Discretionary Review Abbreviated Analysis HEARING DATE: NOVEMBER 8, 2018

Date: October 23, 2018
Case No.: 2015-006138DRP-04
Project Addresses: 2831 Pierce
Permit Applications: 2018.0426.7450
Zoning: RH-3[Residential House, Three-Family]
 40-X Height and Bulk District
Area Plan: N/A
Block/Lot: 0537/001H,
Project Sponsor: Dan Frattin
 Rueben Junius & Rose
 1 Bush Street,
 San Francisco, CA 94104
Staff Contact: David Winslow – (415) 575-9159
David.Winslow@sfgov.org
Recommendation: **Take DR and approve with modifications**

Discretionary Review Hearing
Case Number 2018-006138DRP-04
2831 Pierce Street

Figure 1. Our front deck – 2823 Pierce which is adjacent to the project site

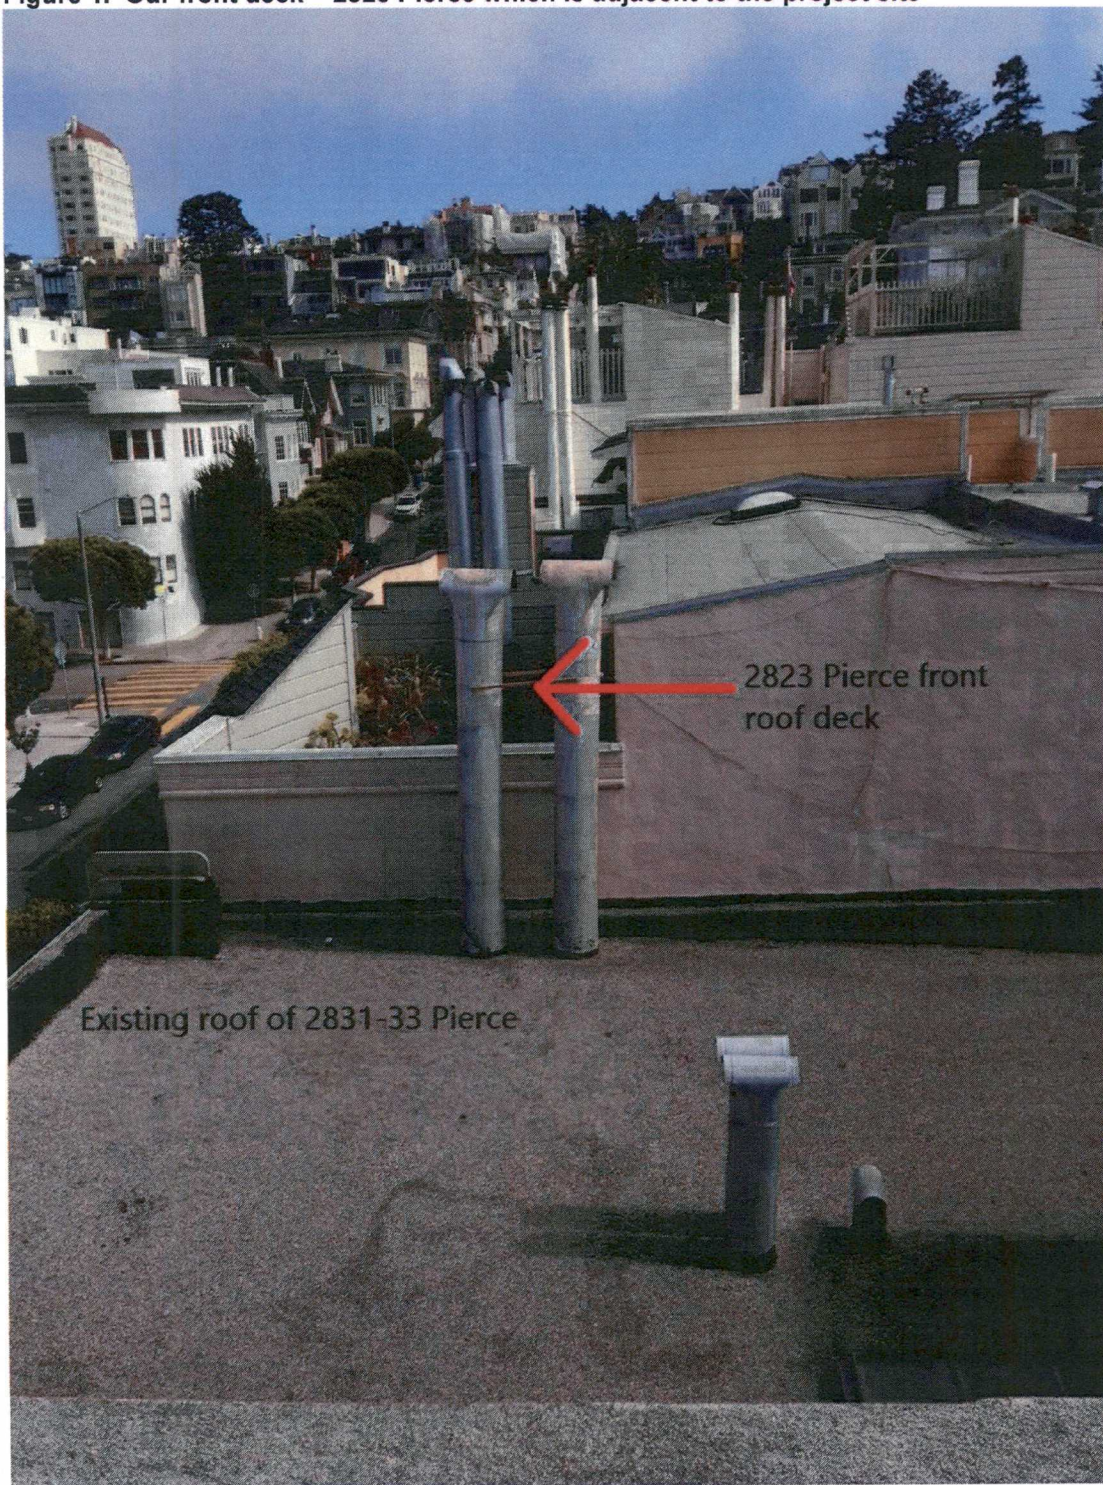
Our front roof deck, shown in **Figure 1**, would be blocked by the project's proposed 3rd floor vertical addition and new front roof deck. **Figure 2** shows approximately where the 3rd floor would be in relation to our front deck. (Figure 2 is an approximation. Although we and other neighbors have repeatedly asked that story poles and massing studies be provided to better understand the precise impacts of the proposed expansion, the applicant has been unwilling to provide these. Accordingly, we are left to make educated guesses about the relationships among the buildings based on the limited drawings the applicant has provided.) **Figure 3** (also an approximation) shows the relationship between me and the parapet with the peak on the Pierce Street side of our deck, which is over my head. Sheet A.2.1, the proposed north elevation attached in Appendix A, shows that the top of the project's proposed third floor at the front property line would reach the top of the peak of the parapet at the front of our deck, rising above our deck railing. This is proposed as a solid wall decorative feature outlining the third story that appears to have no structural necessity. This would essentially wall in our deck.

Figure 4 Existing Conditions – Rear of Project Site and Our Rear Roof Deck

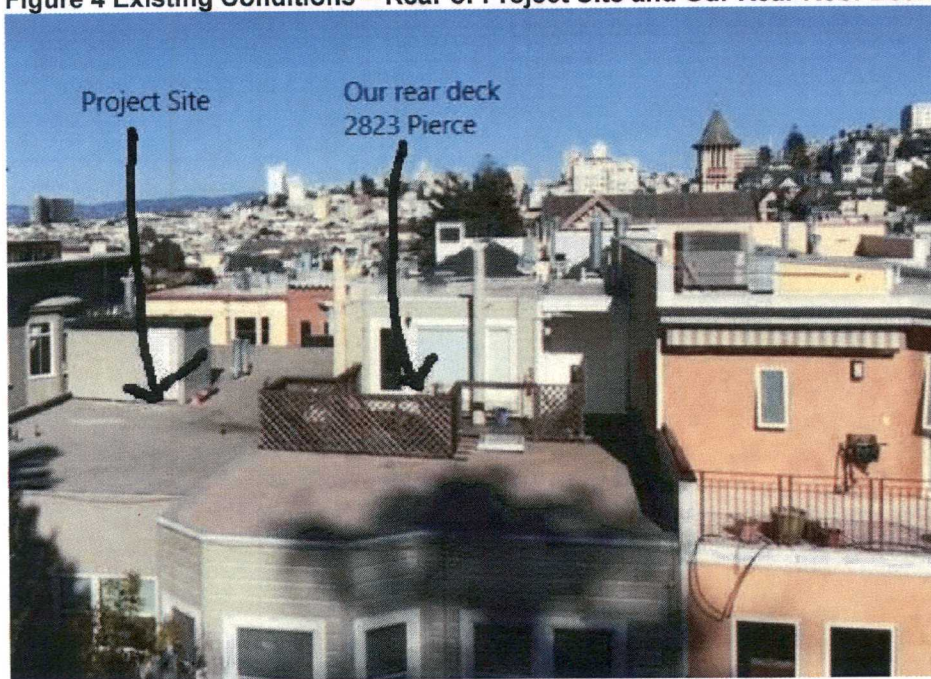
As shown in **Figure 4**, below, the western edge of our existing rear roof deck (marked by the lattice fencing) is set back from the western edge of the 3rd floor roof. Based on a site survey, the roof deck is set back 13.81' from the rear of the third story roof. Our roof deck's northern exposure would be completely blocked by the applicant's proposed rearward expansion. Please note that due to the small size of our unit (721 SF), we are more reliant on our roof decks than others with more sizable units. Therefore, the impacts imposed by the proposed project are more pronounced than they would be for a larger unit.

Figure 5. Existing Windows in 2823-27 Pierce light well that would be blocked by 4th Story

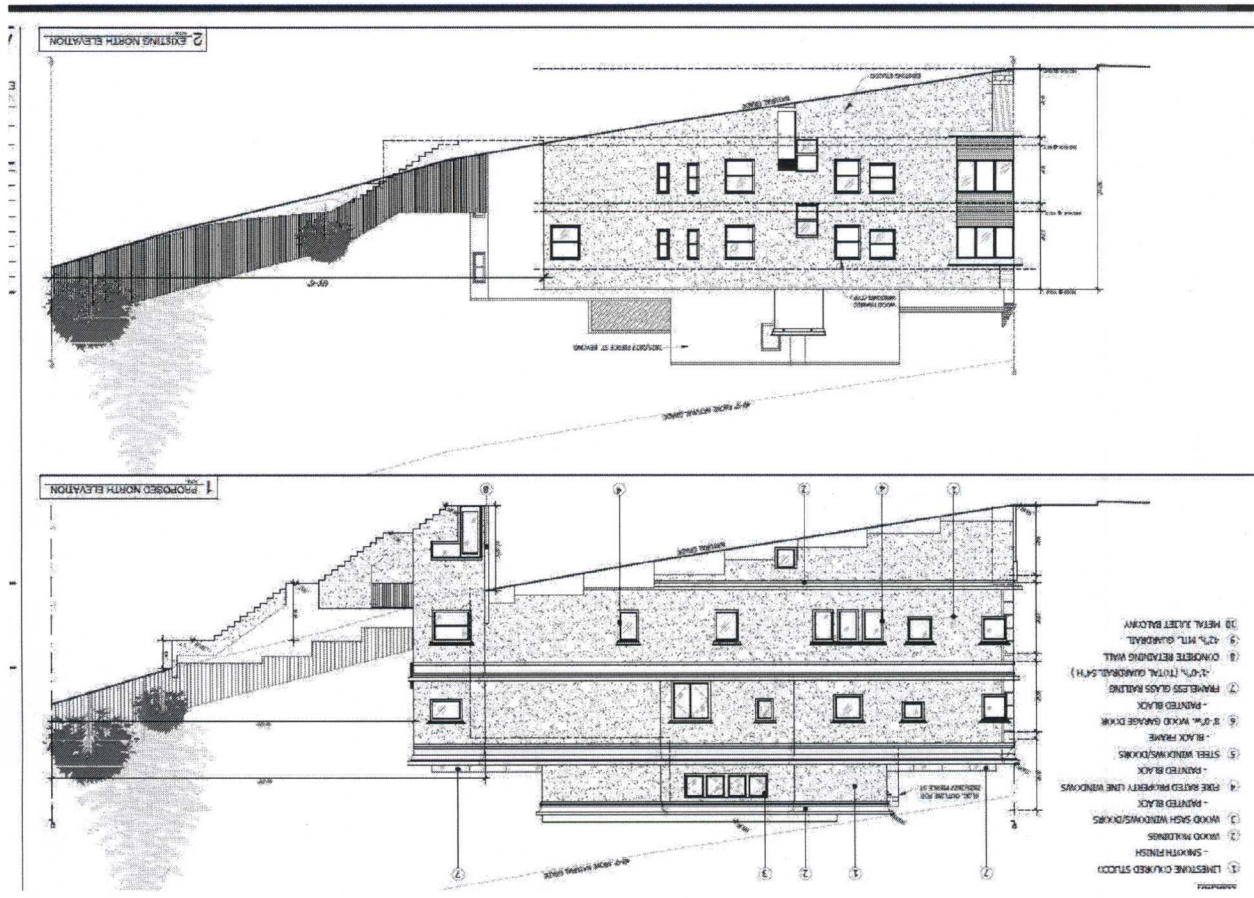
Figure 5 below, shows the existing windows within the light well of our building at 2823-27 Pierce and illustrates how development of a new 4th floor right up to the property line, leaving just one small 3'4' light well (see sheet A1.3 of the plans – Appendix C), would significantly reduce light and air to our home 2323 on the fourth floor, 2325 on the third floor, and to some extent, to 2327 on the second floor.

Existing 2845 Pierce St. windows that would be blocked by project

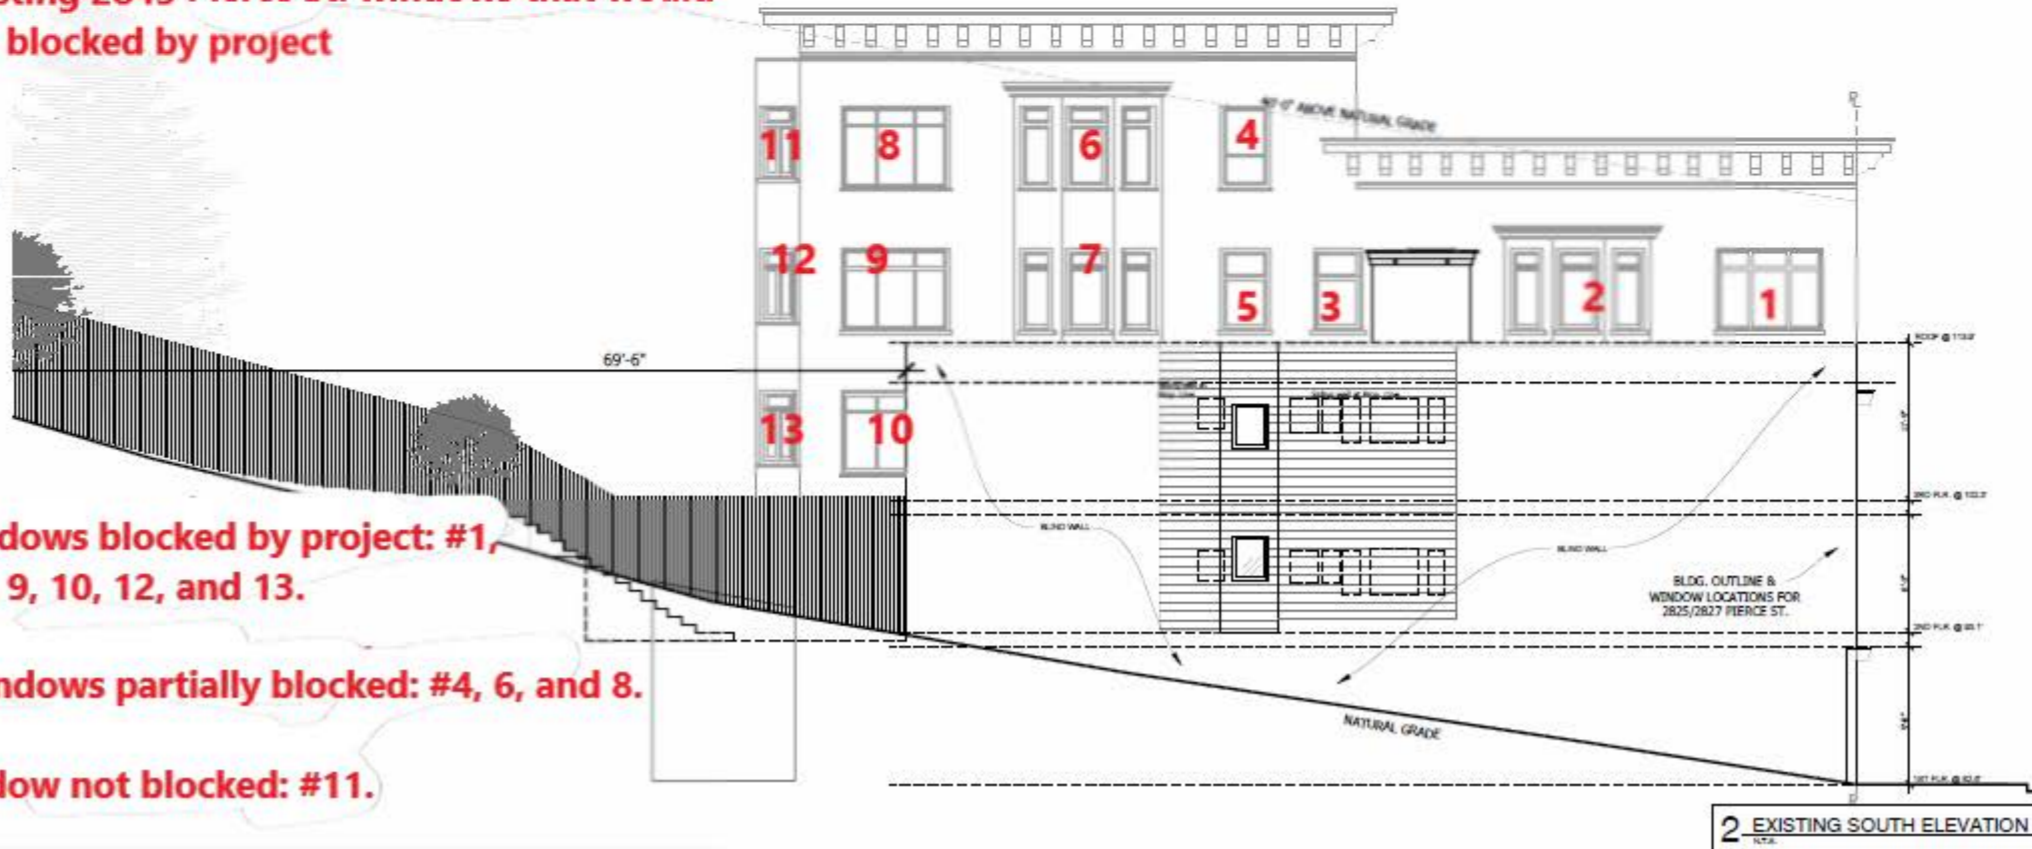
Nine windows blocked by project: #1, 2, 3, 5, 7, 9, 10, 12, and 13.

FIGURE 3 EXISTING AND PROPOSED REAR YARD

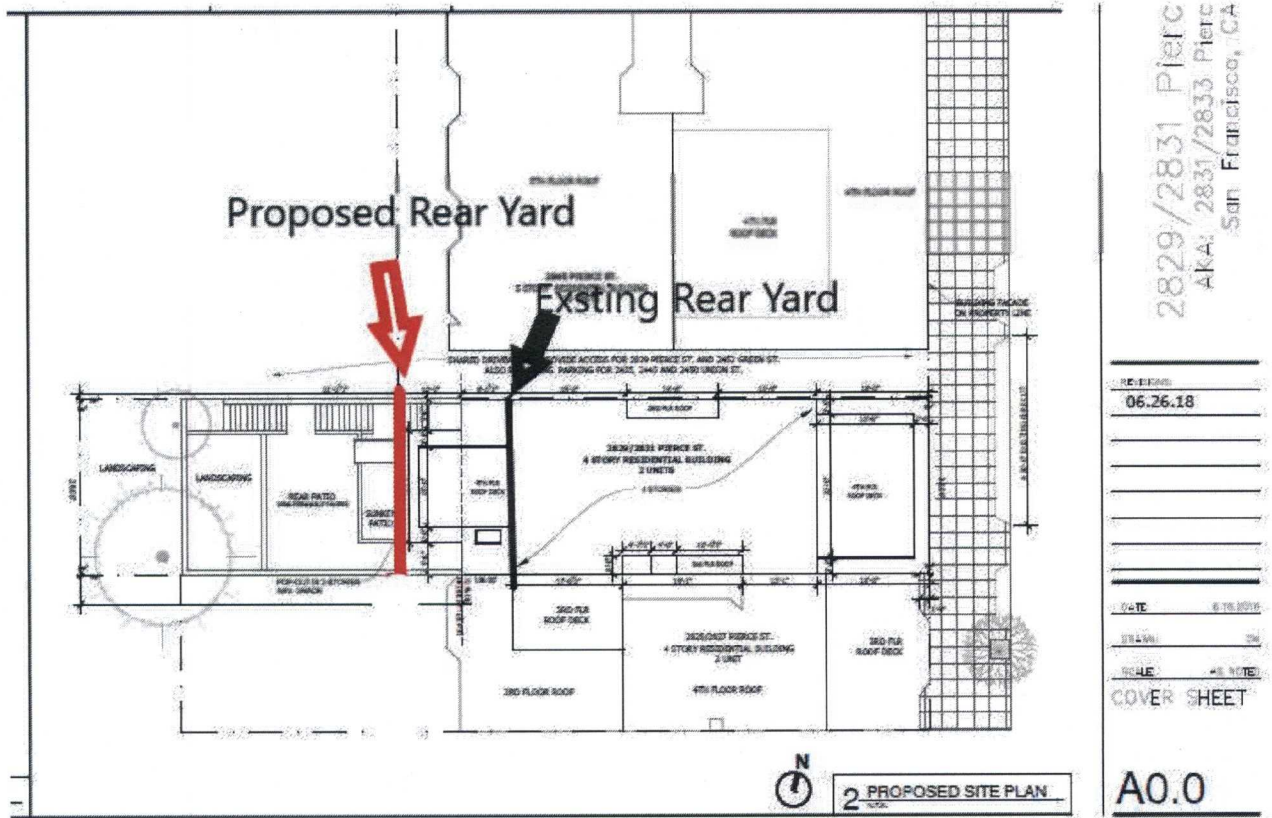
Figure 1 illustrates the established open space pattern and shows how the project would substantially change it. The project will expand the footprint of the building **18 feet** back into the rear yard, significantly reducing the established midblock open space that the block has enjoyed for so many years. Moreover, as shown in Figures 2 and 3, much of the existing landscaped area will be replaced by hardscape, substantially reducing the amount of natural green space. The project site currently has 666 SF of non-permeable surface. This space would be halved under the proposed project to just 332 SF. (Source McMahon Architects + Studio February 22, 2018)

FIGURE 4 2823-27 PIERCE STREET REAR ROOF DECK AND YARD

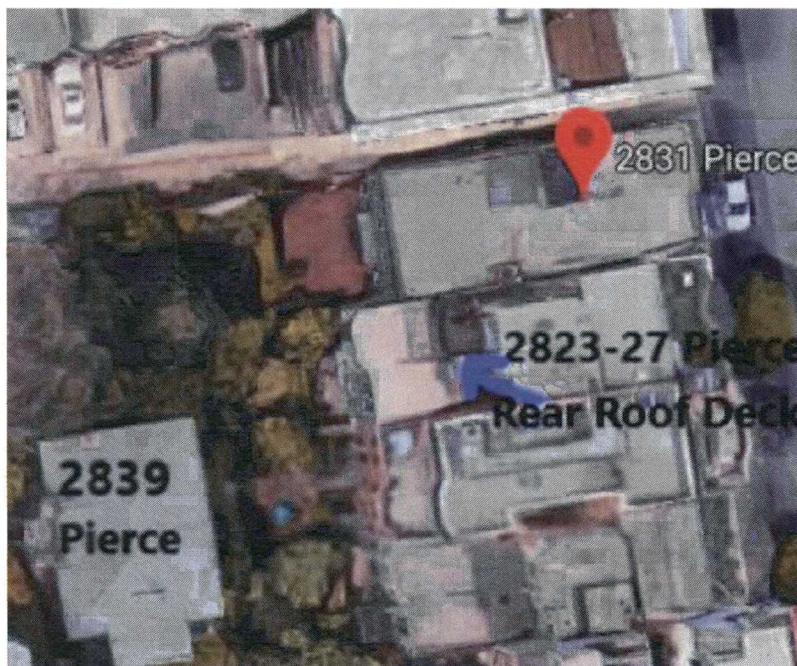
The proposed horizontal and vertical extension of the project into the rear yard would overshadow the rear roof deck of 2823 Pierce, compromising privacy and light and air. Figure 4 shows the roof deck and rear yard space that would be adversely affected. The proposed extension into the rear yard, particularly the large windows at the rear and the fourth-floor rear roof deck (see Figure 2) would look directly into the adjacent building to the west, sacrificing the privacy of these neighbors.

FIGURE 5 SHEET A1.2

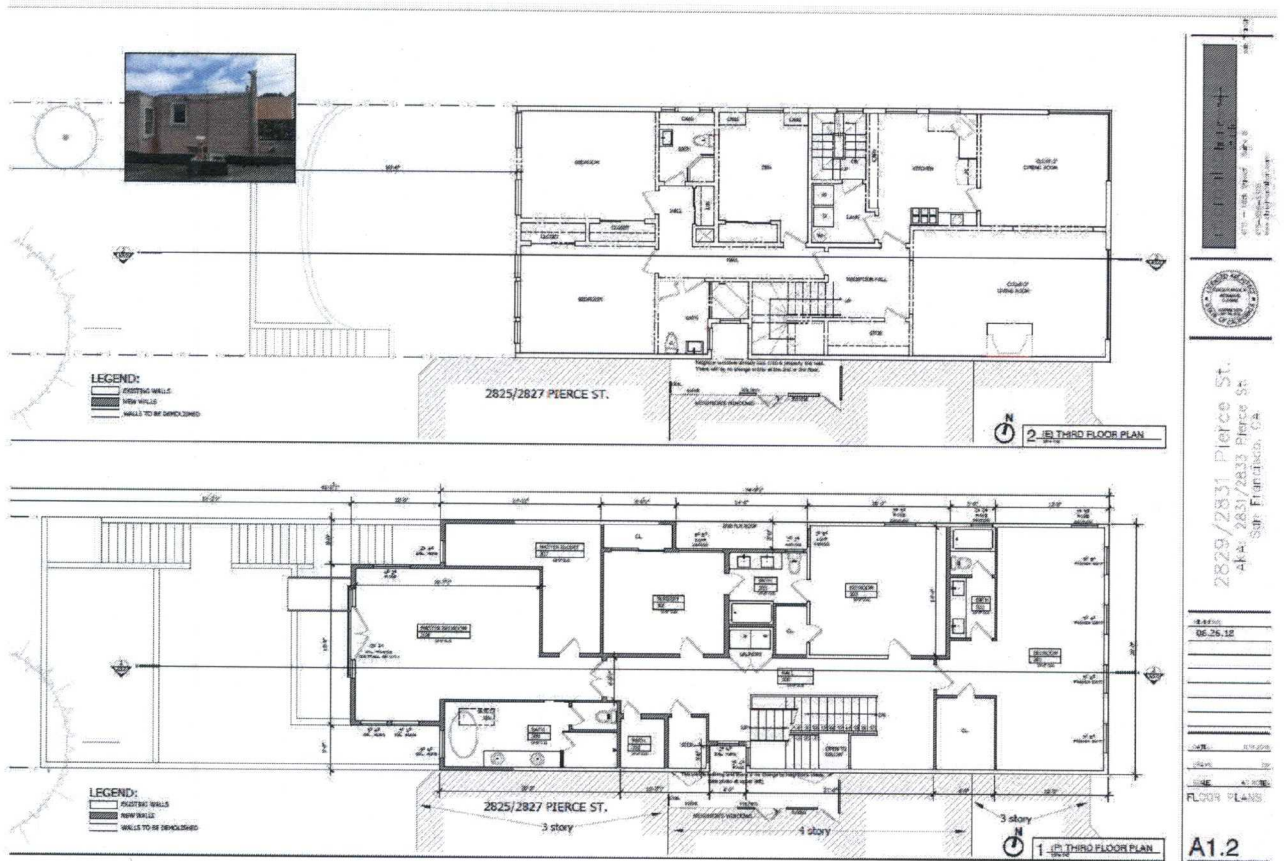
The letter from the Planning Department also required the project sponsor to "reduce the proposed 4th floor to align with the western edge of the existing 4th floor roof" of 2825 Pierce. Once again, the applicant has refused and has extended the fourth floor back further than permitted in the letter. The project must be revised to incorporate this Planning Department requirement.
